GAINES CHARTER TOWNSHIP
PLANNING COMMISSION – REGULAR MEETING
Township Board Room - 8555 Kalamazoo Ave. S.E. Caledonia, MI 49316

DRAFT Agenda

Planning Commission Memo

PROPOSED REQUEST: Special Use
Permit and Site Plan Review

SITE LAYOUT PLAN
DUNKIN DONUTS - EASTPORT
IN PART OF SECTION 5, T5N, R11W
GAINES TOWNSHIP, KENT COUNTY, MICHIGAN

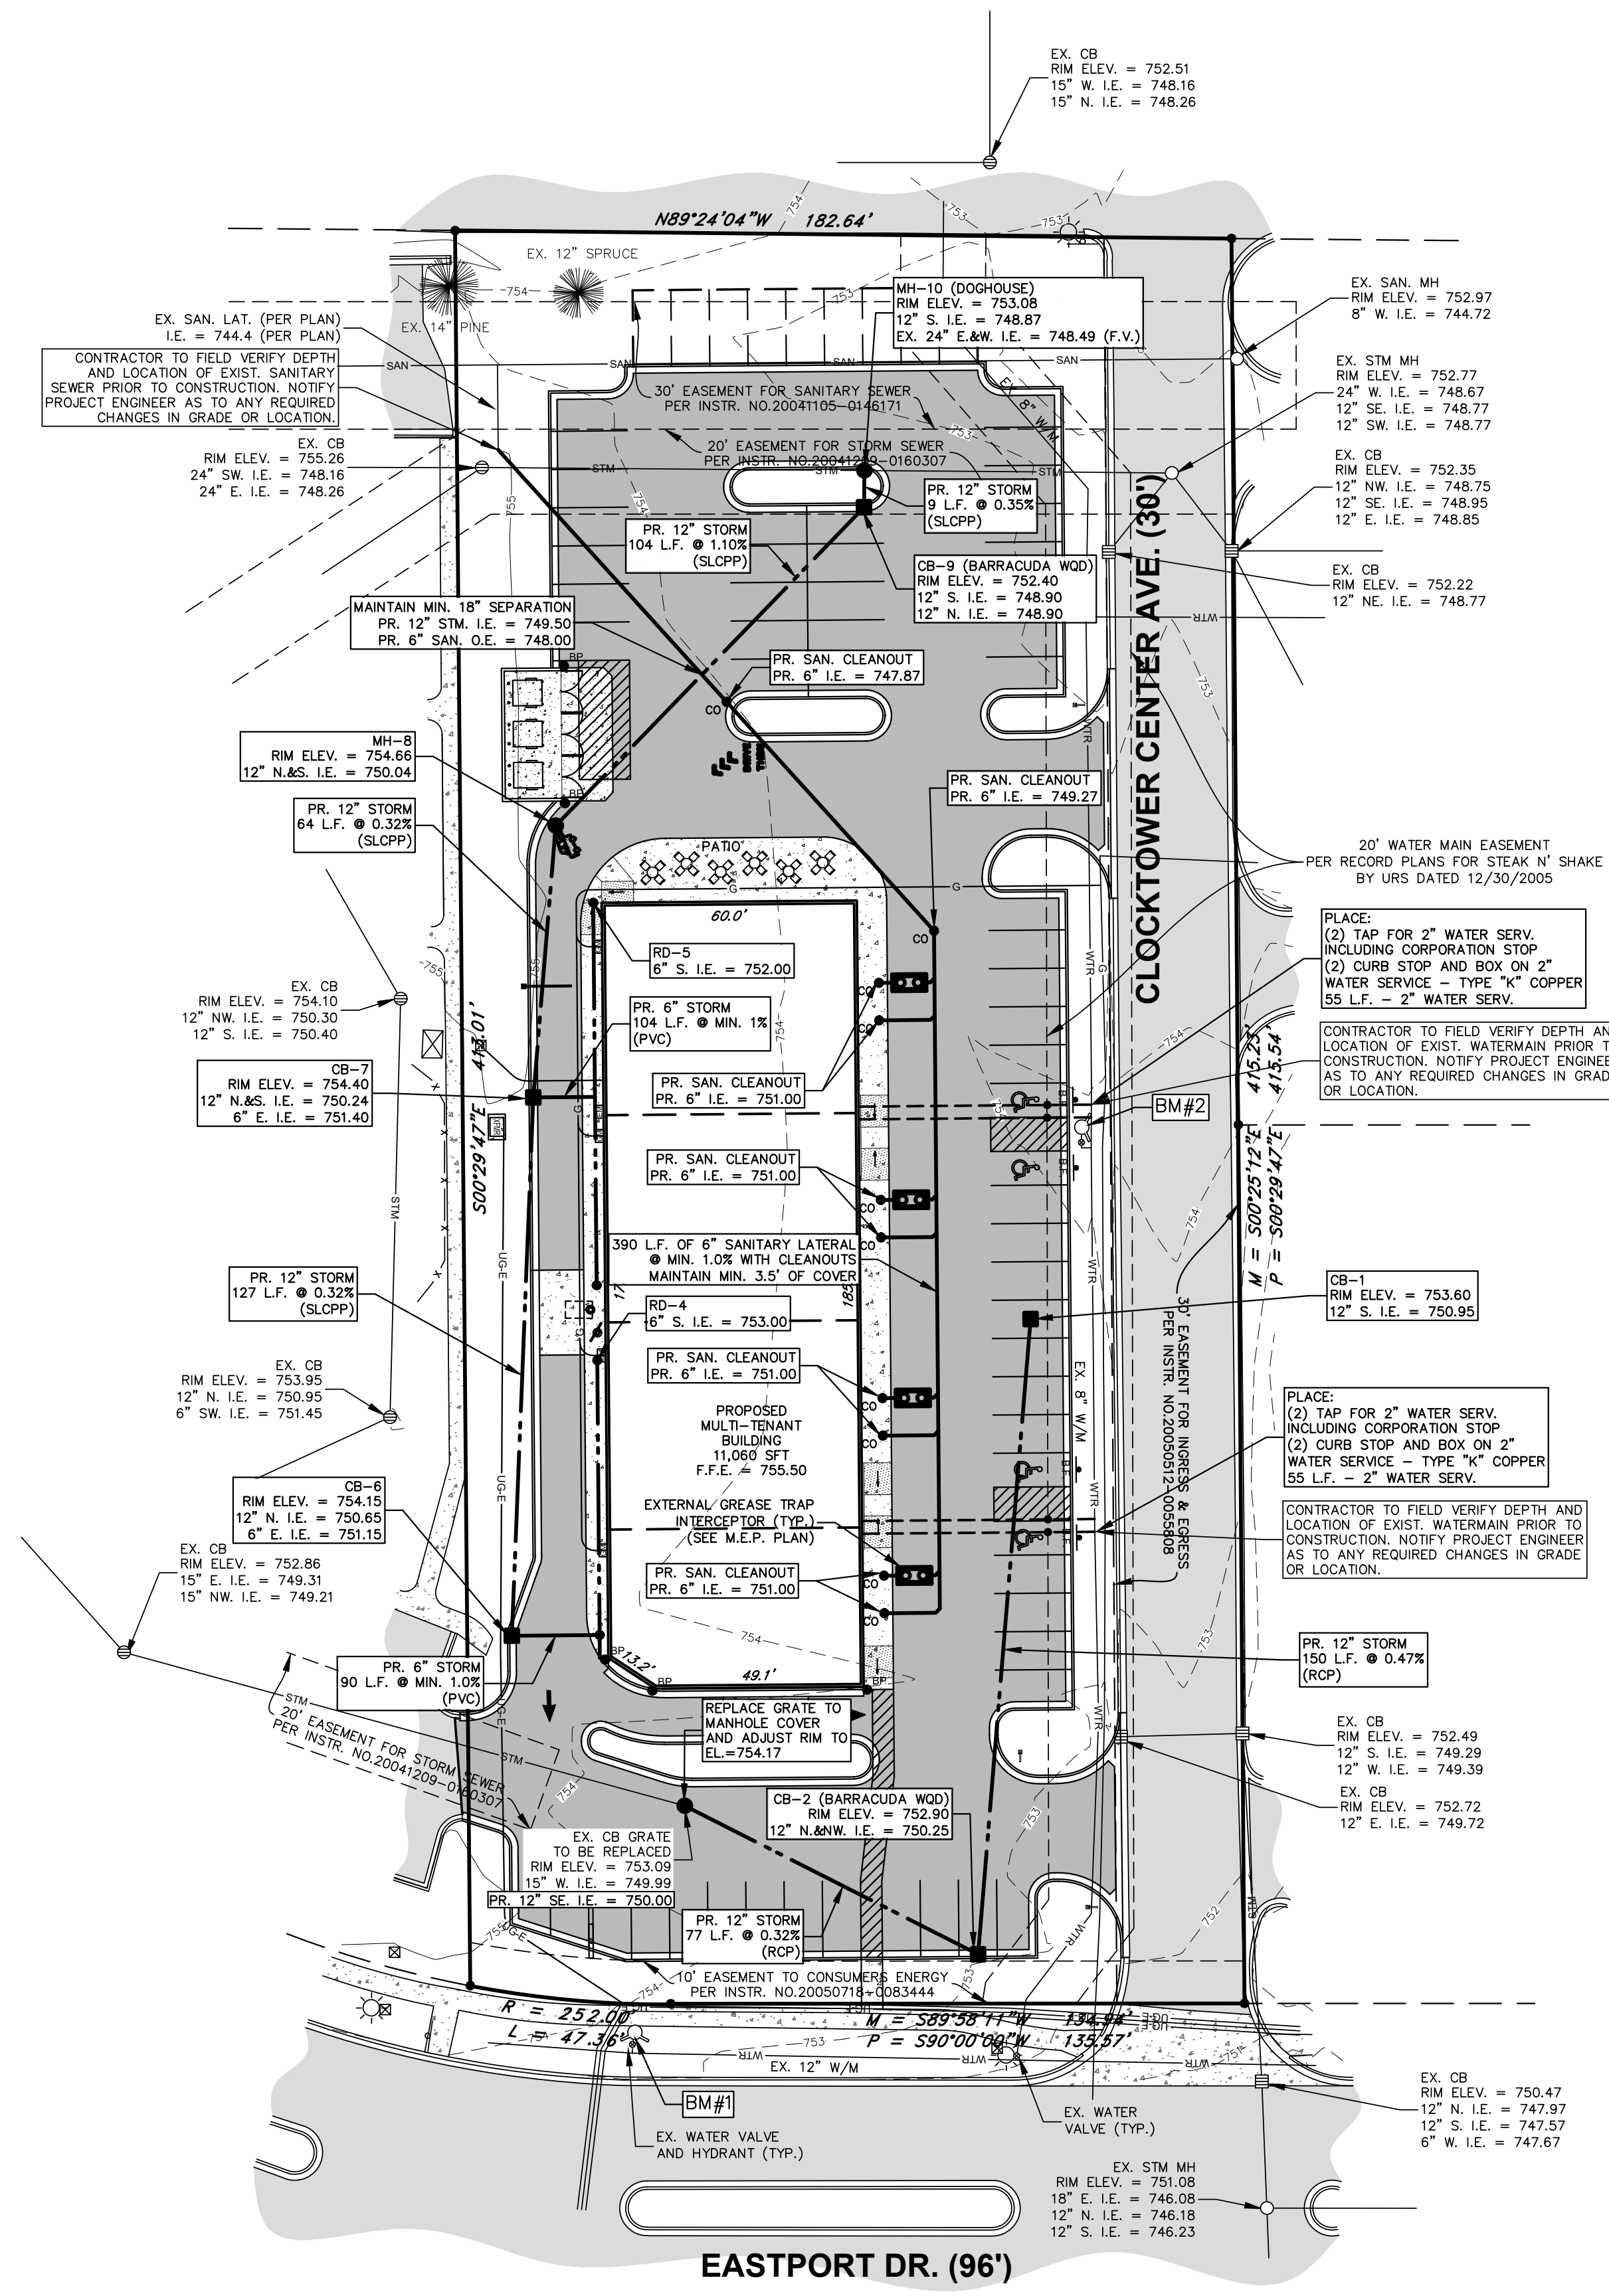
REQUIREMENT	COMPLIANCE	COMMENT
PARKING AND LOADING - CH 20		
Setbacks-10' (20.40.A)	Yes	
Dimensions & Layout (20.40.B)	Yes	
Fire Lanes (20.40.C)	Yes	Fire Marshall has reviewed
Parking Lot Maintenance and Service (20.40.D)	Yes	
Landscape Area Curbs (20.40.E)	Yes	
Landscape Breaks (20.40.I)	Yes	
Drainage and Runoff (20.40.F)	Yes	Township Engineer reviewed
Striping and Pavement Markings (20.40.G)	Yes	
Snow Storage Areas (20.40.H)	No	None noted
Pedestrian Pathways (20.40.J)	N/A

REQUIREMENT	COMPLIANCE	COMMENT
Connectivity (20.40.K)	Undetermined	Connection to parking lot to the west along Eastport may or may not have an easement in place. At the northwest corner, a stub road that connects to this property is not connected.
Lighting (20.40.L)	See "B" above	
Landscaping (20.40.M)	See "E" below	
Accessible Parking (20.50.B)	Yes	4 barrier-free spaces
Minimum Number of Spaces (20.50.D)	Yes	47 spaces required, 58 provided.
Shared Parking (20.60.B)	N/A	
Deferred Parking (20.60.C)	Yes	Space for 9 more spaces is deferred.
Electric Vehicle Charging Stations (20.70)	Not Required	None noted
Loading Zones (20.80)	Yes	12 x 25 space required, providing 12 x 28 space

REQUIREMENT	COMPLIANCE	COMMENT
LANDSCAPING - CH 23		
Type and Variety (23.30.D)	Yes	
Installation Specifics (23.30.E)	Yes	
Planting Separations (23.30.E.5.a)	Yes	
Minimum Installation Sizes (23.30.E.7)	Yes	
Irrigation (23.30.F)	Yes	
Preservation of Existing Trees (23.30.G)	N/A	
Maintenance (23.30.H)	Yes	
Berms (23.30.I)	N/A	No berms indicated on site plan
Prohibited Trees and Shrubs (23.30.J)	No	Pyrus calleryana 'Aristocrat'; ornamental pears are prohibited
Landscaping Plan (23.40.A)	Yes	
Requirements (23.40.B)	No	Needs to be sealed by Michigan licensed landscape architect. Scientific names. Snow storage.
Front Yard Trees Location (23.50.B)	Undetermined	Landscape plan shows trees along Clocktower Center Ave, but this is a utility easement and trees are not allowed.
Buffering (23.60.A)	Yes	44 shrubs required, 44 shrubs provided
Dumpster and Trash Receptacles (23.70.C)	Undetermined	Dumpster location indicated but not construction details.

Parking Lot Canopy Trees-1 tree per 12 spaces (23.80.B)	Yes	58 parking spaces require 5 deciduous trees, 5 are indicated on the site plan
Screening (23.80.C)	Yes

Due to the number of elements either not meeting standards or being undetermined due to lack of information, staff recommends postponing a decision on the Site Plan until those elements are corrected or clarified.
